DwgNo.3419-PL-5002 A

SUNLIGHT HOUSE,
MANCHESTER

PROPOSED SIGNAGE

SIGNAGE DETAIL TO BOTH ENTRANCES

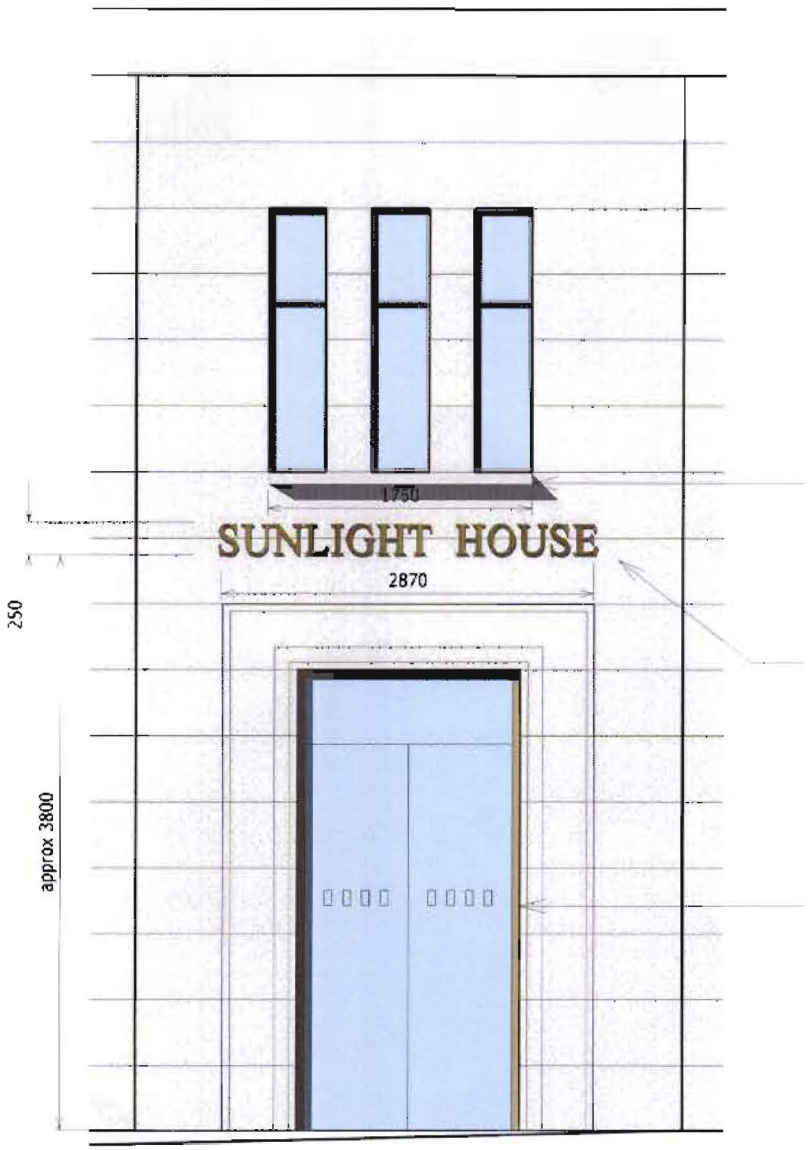
REV A ALS 22/05/08
AMENDED TROUGH LIGHT TO BE EQUAL IN SIZE TO WINDOWS ABOVE AND CHANGED COLOUR. CHANGED FONT SIZE AND TYPE. AMENDED ELEVATION TO SHOW NEW BRONZE WINDOW SURROUND. ALL AS AGREED WITH PLANNING OFFICER.

TROUGH DOWN LIGHTING WITH COLOUR POWDER COATED CASING TO MATCH STONEWORK. COLUR TBC FIXED TO WALL DIRECTLY BELOW WINDOW CILL AS PER EXISTING LIGHTING. TO BE EQUAL IN LENGTH TO EXSITING WINDOWS AS SHOWN

250mm HIGH FLAT CUT BRONZE LETTERING INSTALLED WITH LOCATOR FIXINGS APPROX 30mm FROM WALL FACE
FONT TO MATCH ORIGINAL "SUNLIGHT HOUSE" MOTIF ON INTERNAL ARCHWAY.
"TIMES NEW ROMAN"
OR SIMILAR APPROVED
NEW SIGN TO BE EQUAL/IN LINE WITH ORIGINAL STONE ARCHWAY

PROPOSED BRONZE FRAME TO BE INSTALLED TO NEW WINDOWS & DOOR.
FOR FULL SPECIFICATION SEE DWG NO 3419_PL_5001.
